Access Compliance Report

Public Rights-of-Way

(Curb Ramps)

Intersection ID: 53292	Main Street: PROSPERITY RIDGE RD	Cross Street: I-485_RA	Location:	S
ADA ID: 374110FD6C6E	Ramp Type: Perp	Initial Pass/Fail: Fail	Overall Compliance: No	Severity Score: 12.5

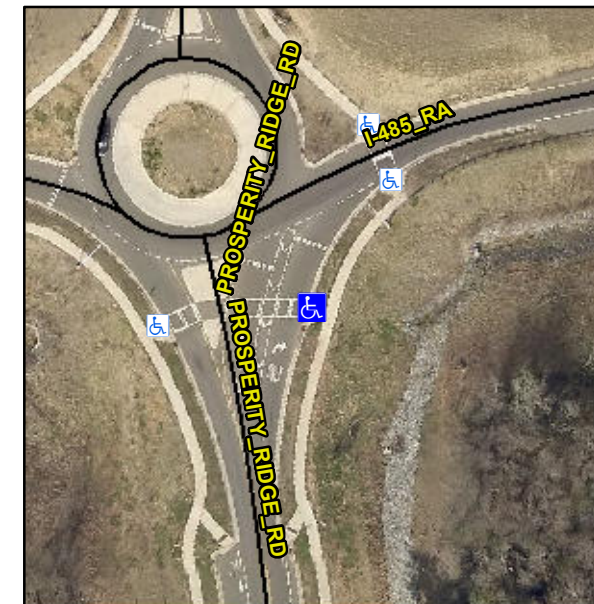
R304.5.3

Compliance	Description	Data	Compliance	Description	Data
N/A	Ramp Length (in)	88.0	Yes	Ramp Slope (%)	6.2
Yes	Ramp Width (in)	48.0	No	Ramp XSlope (%)	6.4
N/A	Flare Type LT	N/A	N/A	Flare Type RT	N/A
N/A	Flare Slope LT (%)	N/A	N/A	Flare Slope RT (%)	N/A
N/A	Flare Traversable LT?	N/A	N/A	Flare Traversable RT?	N/A
N/A	Landing Length (in)	N/A	N/A	DWS Provided?	N/A
N/A	Landing Width (in)	N/A	N/A	DWS Contrast?	N/A
N/A	Landing Slope (%)	N/A	N/A	DWS Length (in)	N/A
N/A	Landing X Slope (%)	N/A	N/A	DWS Full Width?	N/A
N/A	Landing Curb? (Y/N)	N/A	N/A	DWS Offset (in)	N/A
N/A	Shared Landing?	N/A			
N/A	Gutter Ponding?	N/A	N/A	Gutter Slope (%)	N/A
N/A	Gutter Lip Ht (in)	N/A	N/A	Gutter X Slope (%)	N/A
N/A	Painted X Walk1?	Yes	N/A	Painted X Walk2?	N/A
	X Walk 1 Direction	To W		X Walk 2 Direction	N/A
N/A	X Walk 1 Width (in)	105.0	N/A	X Walk 2 Width (in)	N/A
	X Walk 1 Slope (%)	5.3		X Walk 2 Slope (%)	N/A
	X Walk 1 X Slope (%)	3.7		X Walk 2 X Slope (%)	N/A

Remove & Replace Entire Ramp.
